10/550,428

Office Action Summary	Application No. 10/550,428	Applicant(s) MISHRA, PRABHAT RANJAN	
	Examiner ELIZABETH VOLZ	Art Unit 4177

DETAILED ACTION

Figure X

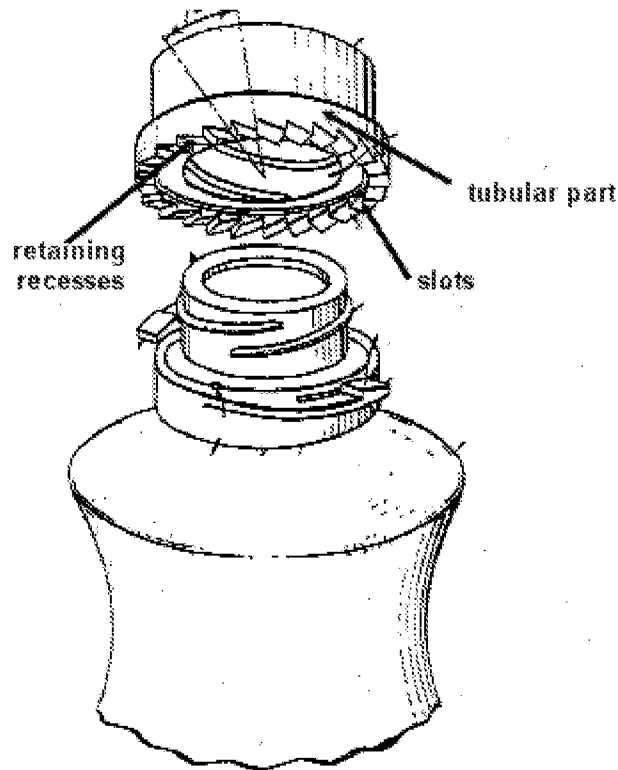
13. Regarding Claims 3, 4, 10, 11, 17, 18, 20 and 21, Landen discloses a closure having one or more co-operating locking lugs 20 (Figure 4) and recesses (Figure 2 and X) to engage the locking ring and cap.

14. Regarding Claim 5, Landen discloses a closure with a cap which has a tubular part (Figure 2 and X) which in use, engages the neck of the container and the cap has locking recesses in the form of longitudinal slots (Figure 2 and X) in the tubular part.

17. Regarding Claims 12, 19 and 22, Landen discloses the locking rim 16 (Figure 4) which has retaining lugs 20 (Figure 4) and retaining recesses (Figure 2 and X) on a flexible part (Column 1, Lines 49-51) of the ring.
